MUNICIPAL AIRPORTS AVIATION ADVISORY COMMISSION  
AND MERRILL FIELD (MRI) USER GROUP COMBINED MEETING MINUTES  
Thursday, April 5, 2017 3-5PM  
Anchorage Fire Training Center  
1140 Airport Heights Road, Building "A" Room 3  
Anchorage, Alaska 99508

Chairman Powell explained this is a special combined MAAAC and Merrill Airport User Group meeting to discuss a proposed reconfiguration of Apron-Taxiway separations. He asked all attendees to introduce themselves, tell of their association with Merrill Field, and reminded all to sign the attendance roster.

Airport Manager Paul Bowers (PB) provided an overview of the proposed TAXIWAY SEPARATION PROJECT, starting with a background review of MRI that explained:

**Figure 2 – TWY N**

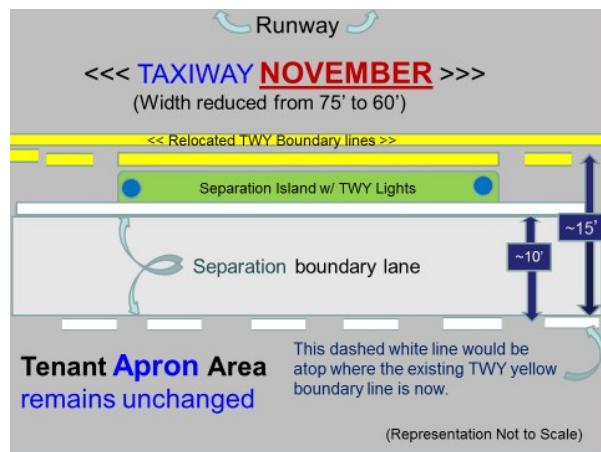
4. **C**, Aircraft traffic on November is different than Alpha. All of the Golf and Quebec apron areas as well as Charlie South and Charlie Transient traffic traverse November. Plus Medevac aircraft traverse November only - not Alpha (plus of course Golf and Quebec) while taxiing to/from the hospital ER, so reducing November width warrants different consideration than Alpha. **A**, Agree, all good points.

5. **Q**, There is an obvious clustering of VPDs mostly on the TWY Alpha side, so why pursue this same treatment for the TWY November side? **A**, Aircraft congestion at the Golf-November intersection and adjacent to ACE fuels, as well as the constrained Apron space along TWY N would be helped with this Separation Lane-Lighted Island concept. Reducing and/or eliminating vehicular traffic adjacent to TWY November will also help and PB stated that will be pursued.

6. **C**, Because of the clustering of VPDs along TWY Alpha and less so on TWY November, why not restrict vehicle traffic to all businesses-along-November to access via Merrill Field Drive only to address the November side issues? **A**, Clearly all businesses along TWY November can be accessed via Merrill Field Drive and with our recently installed vehicle gate ingress/egress system, access control can indeed be so restricted – and it will be.

1. ALL TWY November business/tenant access will be only via Merrill Field Drive. Driving parallel to November will not be allowed (other than MRI, APD and tenant SRE efforts), likely starting May 1.
2. Any to be installed Islands they will be green painted asphalt, not grass-filled cut-into-asphalt.
3. Any additional taxiway lights will be standard above ground frangible light stems, not flush mounts.
4. Some type of restrictive parameter is necessary to keep drivers off TWY Alpha and a vehicle separation lane will be implemented. Whether that comes out of the indi-

**Figure 3 – TWY A**

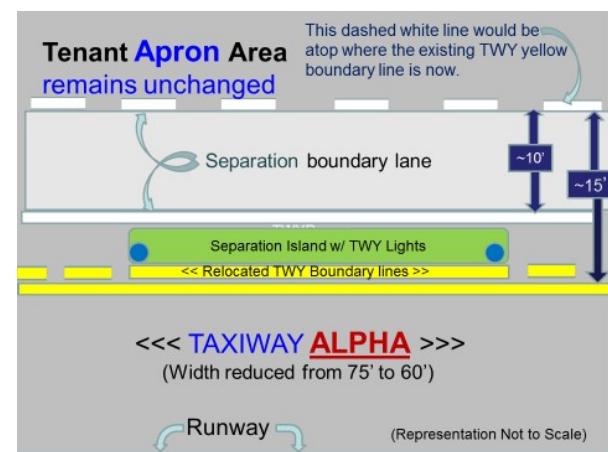
However, on the north / TWY Alpha side – complements of the elimination of the 5<sup>th</sup> Av frontage road when 5<sup>th</sup> Ave was widened – AOA and TWY Alpha side business/tenant access is only via four 5<sup>th</sup> Ave cul-de-sac access points and the vehicle gate at Stoddards. So vehicle driving onto the AOA is necessary in many cases – and is the *only* access for several. That access must be either across individual tenant apron ramps or adjacent to the taxiway - and therein is a problem. Better signage will help and better informed customers/guests by the respective businesses or tenants will also help, but some type of restrictive parameter is necessary to keep drivers off the taxiway.

- vidual leaseholds or the taxiway width remains TBD (latter is likely). Some type of MRI funded address of TWY Alpha portions of this may be implemented in 2017.
5. North side vehicle access via the N8 vehicle gate at Stoddards will not be available for other than Stoddards customers. No more access for convenience to any area along Alpha because Stoddards Way access is easier than 5<sup>th</sup> Av access. Gate codes will be changed accordingly.
  6. A reiteration that tenants have (or should have) control of their leasehold spaces. Many – not all – VPD cases have resulted from failure to control AOA access by customers/patrons, via left open gates/doors, not awaiting vehicle gate closure after entry or exit, and not reporting a gate failure situation. Much of this discussion of Safety related VPD reduction would be unnecessary if better address of these items were to occur.

**Figure 4. Strategic Placement of the Separation Islands Overview**

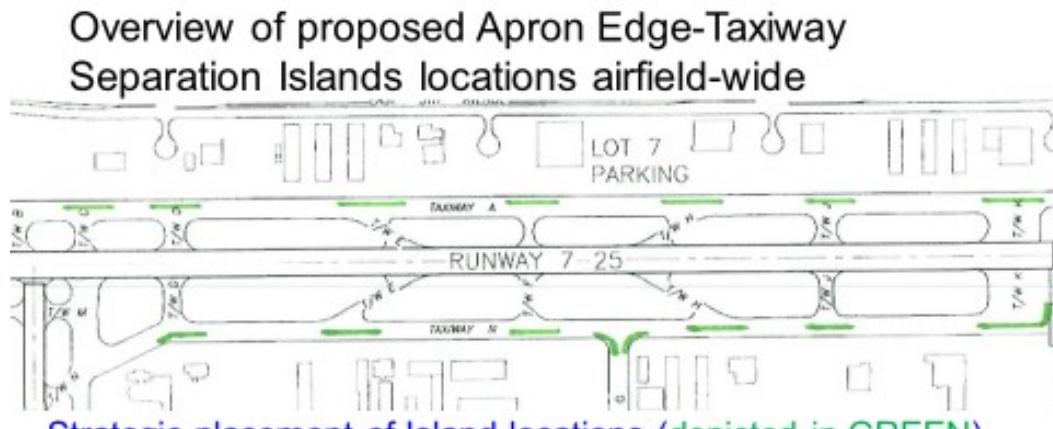
7. **Q**, Would islands be an above ground barrier of any type? **A**, No, nothing above surrounding surface asphalt except taxiway frangible light stems.
8. **Q**, If potential prop strikes can (will) occur with TWY light stems, why not use flush-mount (“flush” with the asphalt surface) sunken lights? **A**, ‘Flush mount’ lights actually protrude above the surrounding surface  $\frac{1}{2}$ ” to 1”, thereby requiring a poly or Lexan material moldboard (the ‘moldboard’ is the wearing or cutting edge on Snow Removal Equipment (SRE) blades). Steel edges will snag the ‘flush’ lights. Snags damage the blades and/or tear out/off the light lids.

9. **C**, Cutting into the asphalt to create grass islands would create more problems than it would address: aircraft excursions into/onto an island could create nose gear/tire issues/even stuck aircraft if the ground is soft; grass mowing would add costs, mandate ATCT coordination, and create inconvenience to TWY users; grass areas could become a waterfowl attractant, may need insecticide spraying for grass hoppers; cuts into the asphalt would allow water penetration which could create unforeseen problems and may exacerbate drainage; snow removal becomes more problematic; simply painting asphalt surface green would finesse all of these points, except prop strikes that could occur with additional taxiway lights stems. **A**, PB agreed with all points, particularly that green-painted asphalt simplifies and resolves most points made in this regard. He noted rebuttal concern expressed regarding painted surface asphalt were that many pilots would simply ignore them and drive or taxi across at will, and if this were the case, taxiway light stem prop strikes would be even more likely. Also, strategically placed painted Islands that were fully ‘drivable’ would not necessarily create airport geometry that would force the pilot to consciously make turns to promote situational awareness to/from aprons.

10. **C**, Islands at Spernak’s look like they would exacerbate aircraft parking space. **A**, PB noted approximately 31% of Spernak’s lease lot is used for vehicle parking. It would appear reconfiguration and/or better utilization of the lot could help address the congestion.

11. **C**, A graduated approach may be appropriate; i.e. do a partial or temporary paint only arrangement rather than an engineered permanent cutting-into-the-asphalt installation. **A**, A graduated approach may indeed be practical. Downside is any piecemeal approach will be a 100% MRI cost, w/o any grant funding. Certainly more emphasis and VPD reduction concern on the part of all parties will help.

Generally flush mount lights are only found at Part 139 Category I, II, II airports (where RWY centerline lights are required for such categorization). Because of above practicality and cost issues, MRI will not be installing flush mount lights.
